Access Compliance Report

Public Rights-of-Way

Intersection ID: 25211	Main Street: SMITH_RD	Cross Street: SOUTHBRIDGE_FOREST_DR	Location: SW
ADA ID: 9AC317D6E7D5	Ramp Type: Perp	Initial Pass/Fail: Fail	Overall Compliance: No
		Severity Score: 12.5

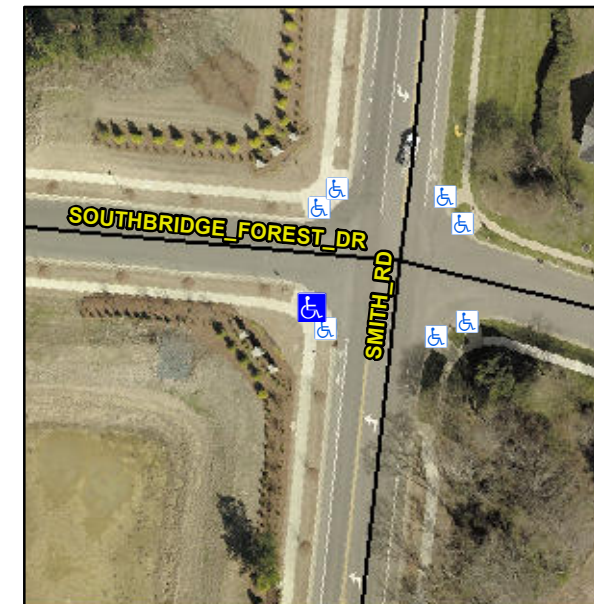
Not Found, R304.5.3

Compliance	Description	Data	Compliance	Description	Data
N/A	Ramp Length (in)	97.0	Yes	Ramp Slope (%)	6.0
Yes	Ramp Width (in)	48.0	No	Ramp XSlope (%)	6.3
N/A	Flare Type LT	N/A	N/A	Flare Type RT	N/A
N/A	Flare Slope LT (%)	N/A	N/A	Flare Slope RT (%)	N/A
N/A	Flare Traversable LT?	N/A	N/A	Flare Traversable RT?	N/A
N/A	Landing Length (in)	N/A	N/A	DWS Provided?	N/A
N/A	Landing Width (in)	N/A	N/A	DWS Contrast?	N/A
N/A	Landing Slope (%)	N/A	N/A	DWS Length (in)	N/A
N/A	Landing X Slope (%)	N/A	N/A	DWS Full Width?	N/A
N/A	Landing Curb? (Y/N)	N/A	N/A	DWS Offset (in)	N/A
N/A	Shared Landing?	N/A			
N/A	Gutter Ponding?	N/A	N/A	Gutter Slope (%)	N/A
N/A	Gutter Lip Ht (in)	N/A	N/A	Gutter X Slope (%)	N/A
N/A	Painted X Walk1?	No	N/A	Painted X Walk2?	N/A
	X Walk 1 Direction	To NE		X Walk 2 Direction	N/A
N/A	X Walk 1 Width (in)	N/A	N/A	X Walk 2 Width (in)	N/A
	X Walk 1 Slope (%)	1.0		X Walk 2 Slope (%)	N/A
	X Walk 1 X Slope (%)	4.0		X Walk 2 X Slope (%)	N/A

Remove & Replace Entire Ramp.
